Annex A

Responses-to-Comments Table

Revised Sewerage Impact Assessment

APPLICATION FOR PLANNING PERMISSION UNDER SECTION 16 OF THE TOWN PLANNING ORDINANCE (CAP. 131) FOR PROPOSED HOTEL USE AND MINOR RELAXATION OF PLOT RATIO RESTRICTION AT "OTHER SPECIFIED USES" ANNOTATED "BUSINESS (1)" ZONE AT NO. 646 - 648A CASTLE PEAK ROAD, CHEUNG SHA WAN, KOWLOON

Drawing Title
1ST FLOOR PLAN

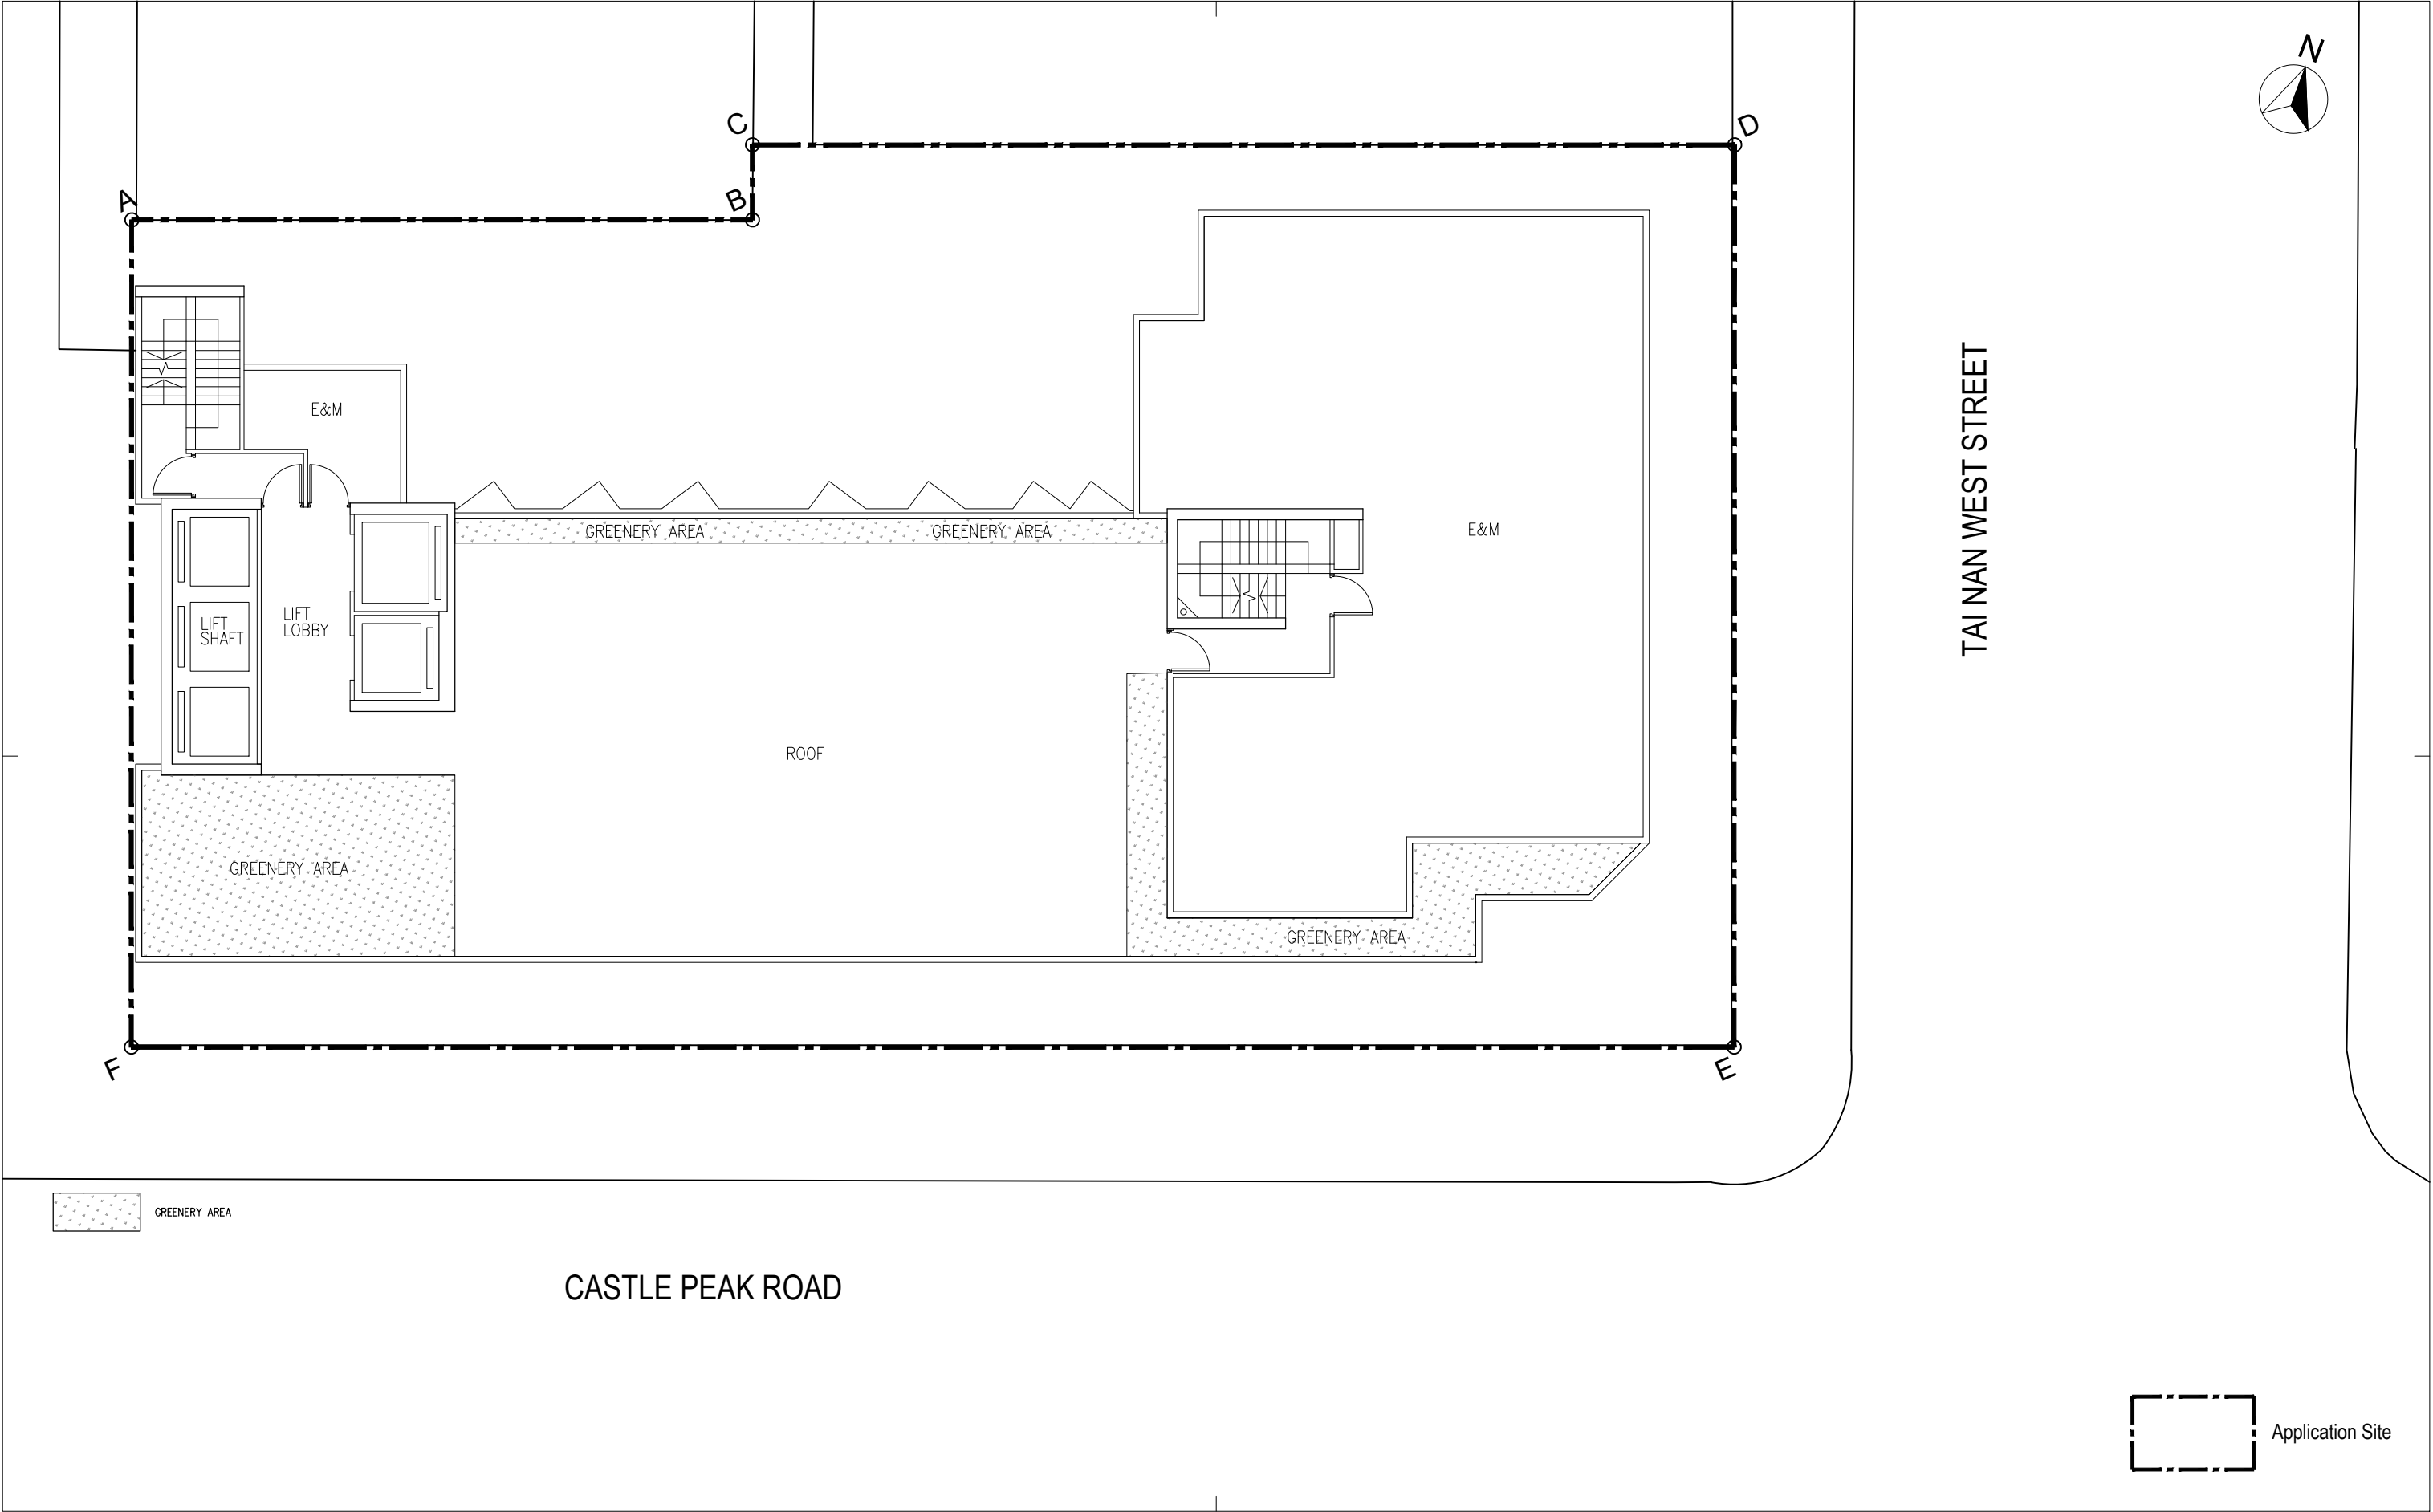
8. 1st Floor Plan – Please advise if the Greenery Area is part of the canopy. If affirmative, please revise the annotations in the plan for the sake of clarity.	Please note that the Greenery Area is part of the canopy. The annotation is revised to “greenery on the canopy”. Please refer to the revised Architectural Layout (Annex D refers)	
	Appendix B
